3.0 Site-Specific ITAAC

Table 3.0-1 Ultimate Heat Sink (UHS)

Figure 3.0-1 UHS and Reactor Service Water System

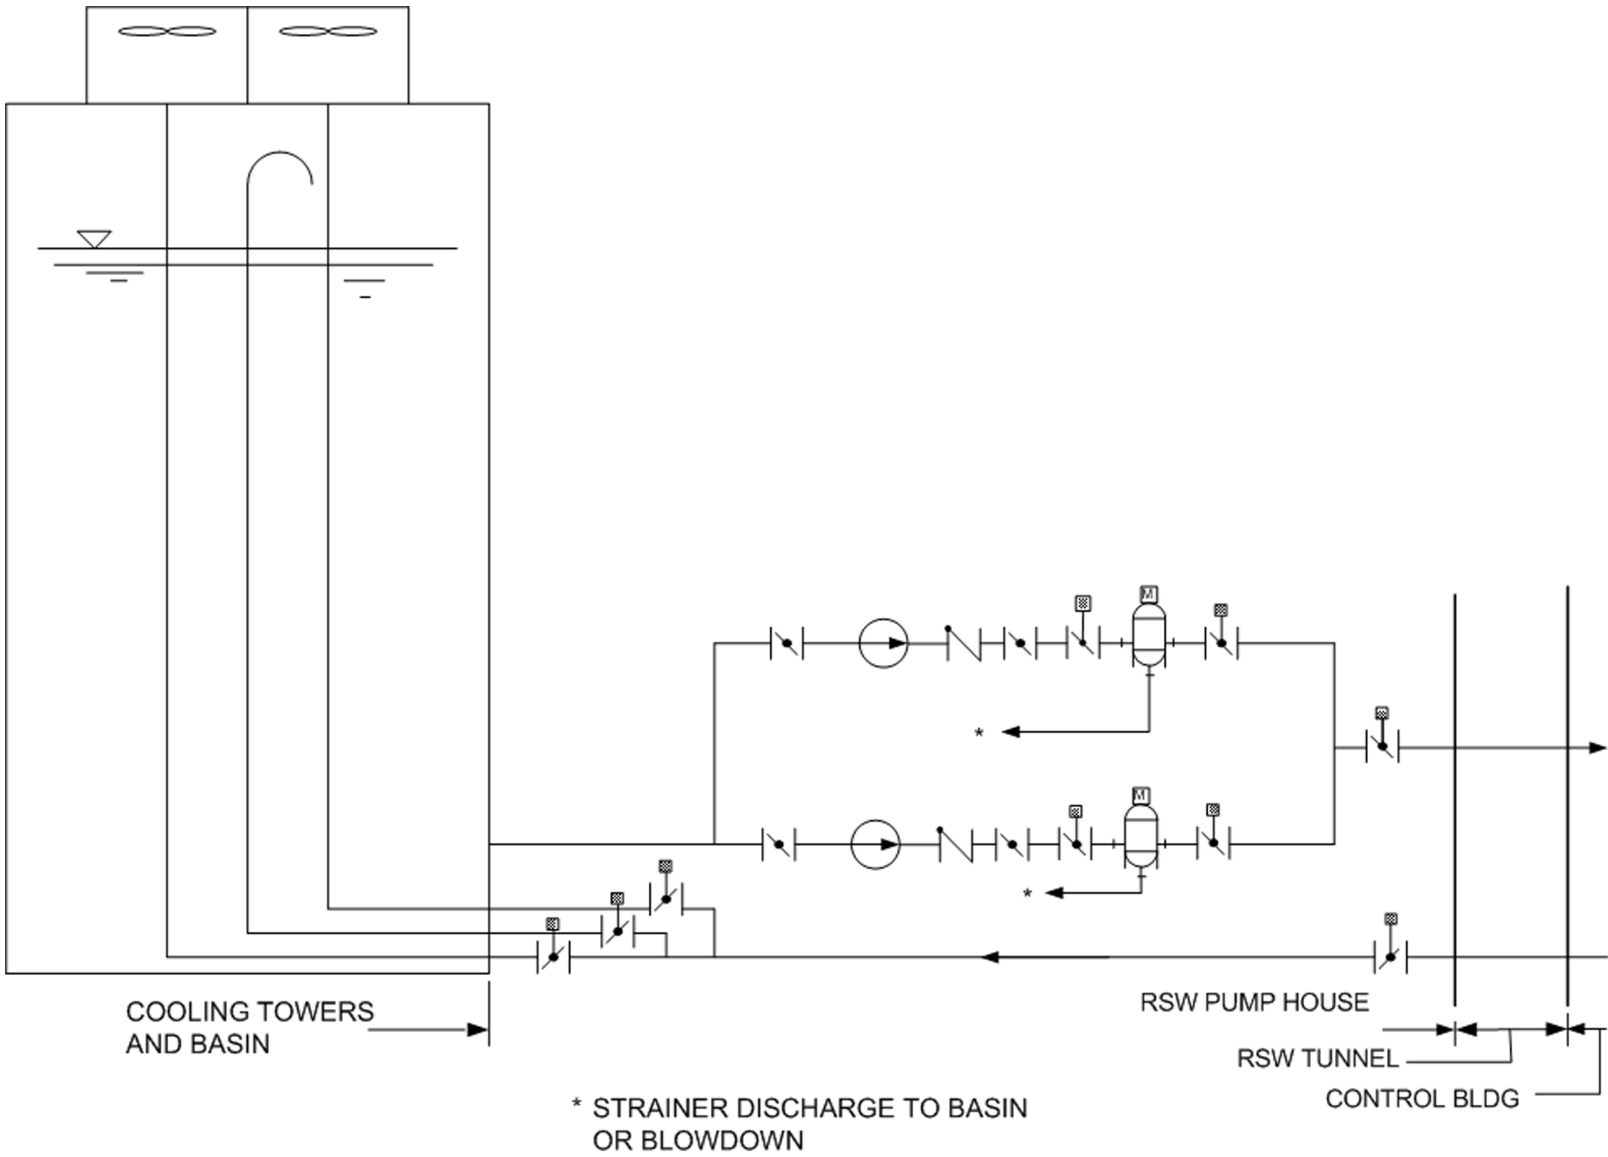
Design Requirement	Inspections, Tests, Analyses	Acceptance Criteria
1. The basic configuration of the site-specific RSW is as shown on Figure 9.3-4 3.0-1.	1. Inspections of the as-built system will be conducted.	1. The as-built RSW conforms with the basic configuration shown on Figure 9.3-4 3.0-1.

Design Requirement	Inspections, Tests, Analyses	Acceptance Criteria
5. Displays and controls in the main control room and RSS are provided for required functions of the RSW system.	5. Inspections will be performed on the main control room and RSS displays and controls for the RSW system.	5. Displays and controls exist in the main control room and RSS as shown on Figure 9.3-1 3.0-1.
